ELEVATOR SERVO MOUNT ADDENDUM

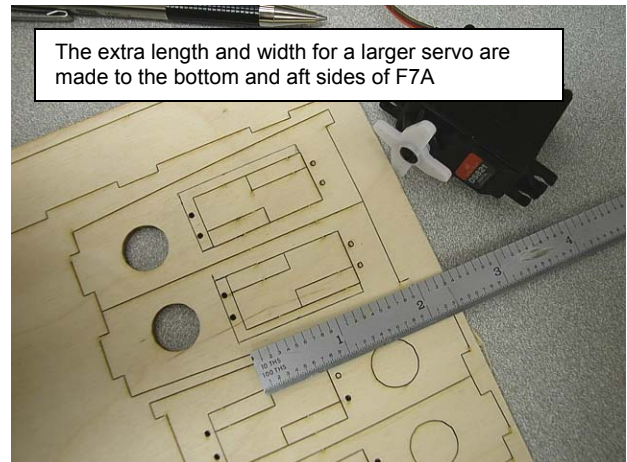
On page 34 of the Electra instruction manual, there is mention of two additional F7A formers that will allow the installation of a larger, standard size servo such as the Spektrum DS821. These formers are found on the 1/8" Baltic ply sheet LC028. In the event that the LC028 supplied with your kit has the extra formers but with cutouts for the mini sized servos only, you can quickly modify two of the formers to accept a larger servo.

- Measure your servo and draw the extra width and length lines directly onto the Baltic parts. Note that the length is increased towards the small lightening hole at the aft end of F7A and the width is increased towards the bottom of F7A indicated by the small tab at the front.

- Use a Drum sander to take away most of the material then a razor knife and scuff board to clean up the corners. Complete the rest of the steps as per the manual.
